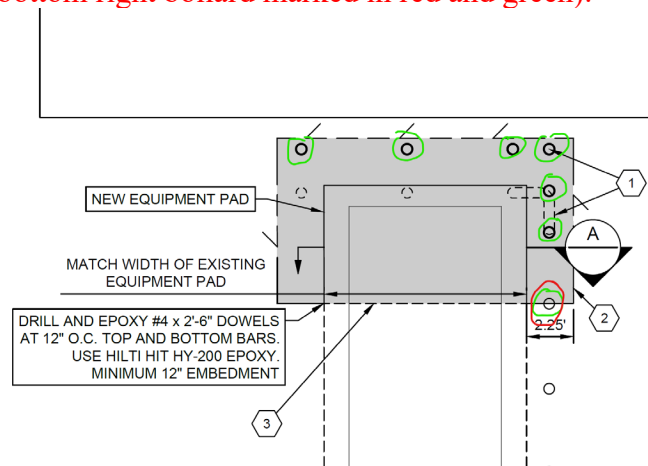
17. Sheet C-001 note #1 says there are 7ea new bollards to be installed per the details but only 6ea bollards are shown. Where is the location of the 7<sup>th</sup> bollard?

- a. Answer: See 7 marked bollards in screenshot below. The bottom right bollard marked in green and red was not properly marked in drawing set and may not require removal, although it could need to be removed. Plan on the removal of 4 bollards instead of 3 (the bottom right bollard marked in red and green being the 4<sup>th</sup>). Also plan on the installation of all 7 bollards as marked below (including the bottom right bollard marked in red and green).

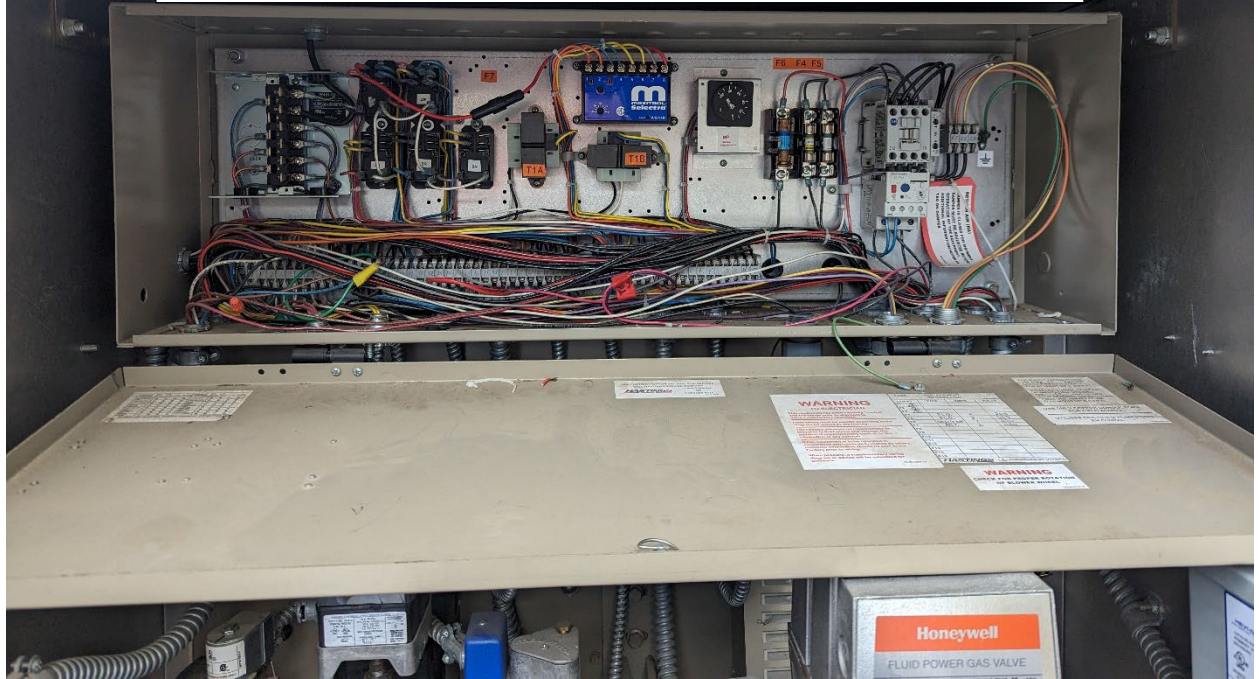
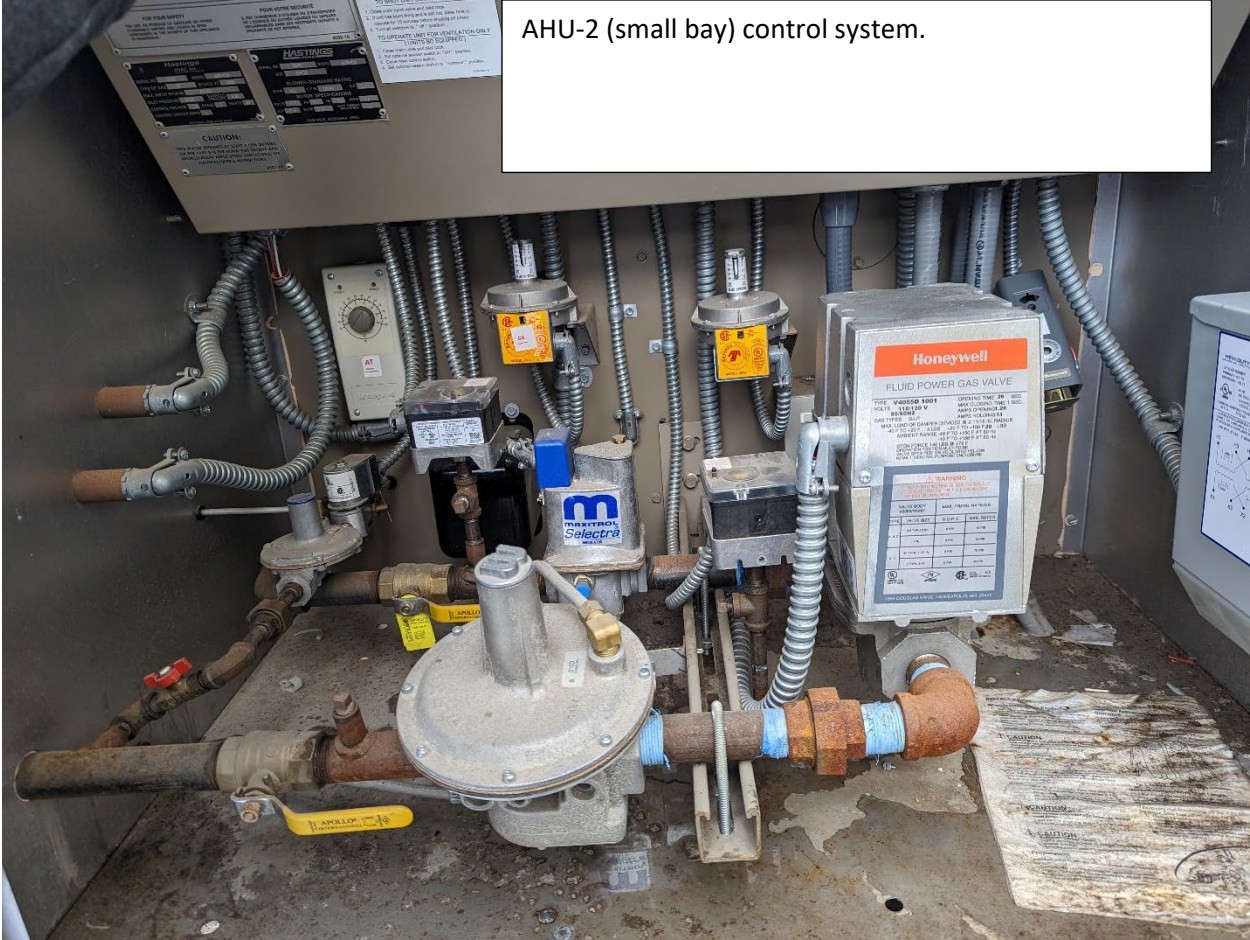
14. Please provide pictures of all HVAC controls, panels, conduit, etc.

15. Please provide pictures of the HVAC ducting, leaders, conduit, electrical panels, transformers, etc.

16. Please provide pictures of the VFD's, conduit, controls, etc.

- a. Answer: see pictures at end of this document.

- a. Answer: see pictures at end of this document.

- a. Answer: see pictures at end of this document.

MDP in NE corner of large bay.

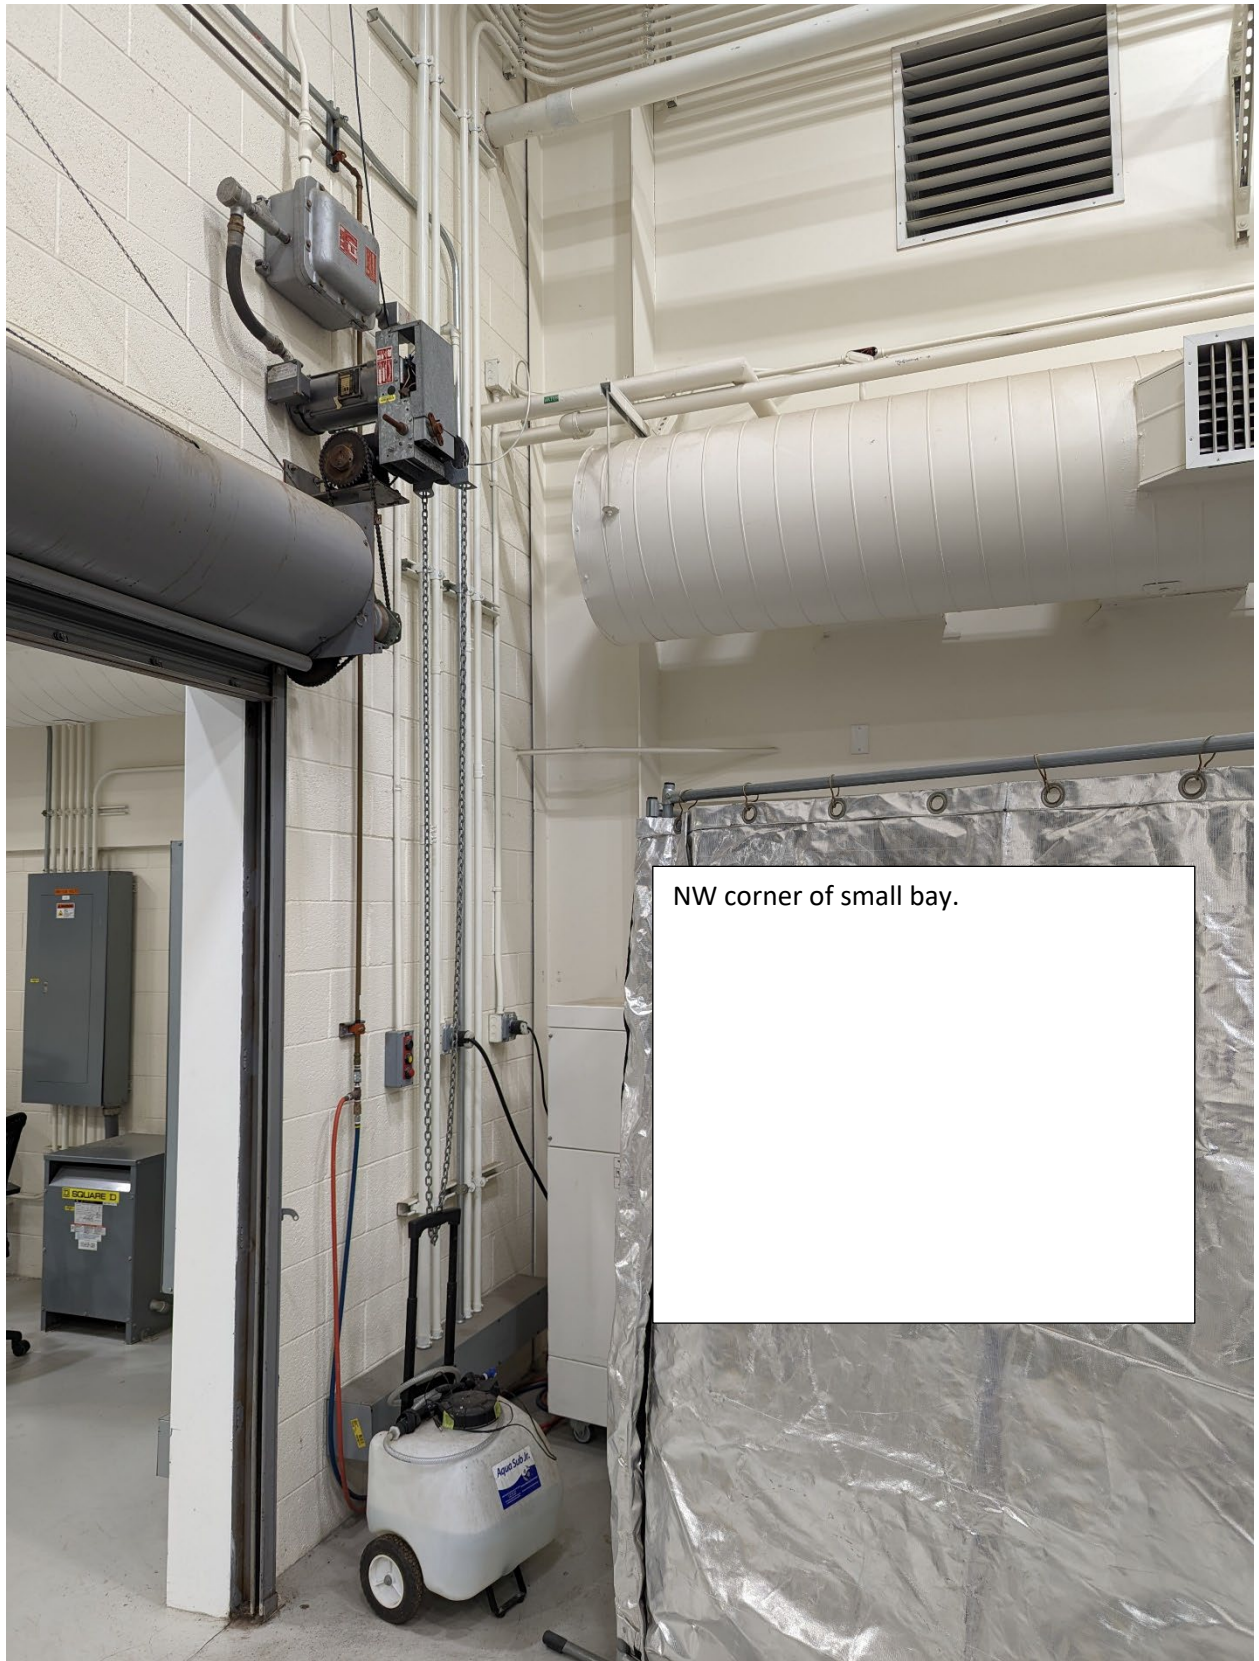
12. Please provide photo of "MDP" with name plate information that we are to provide and install new breakers in.
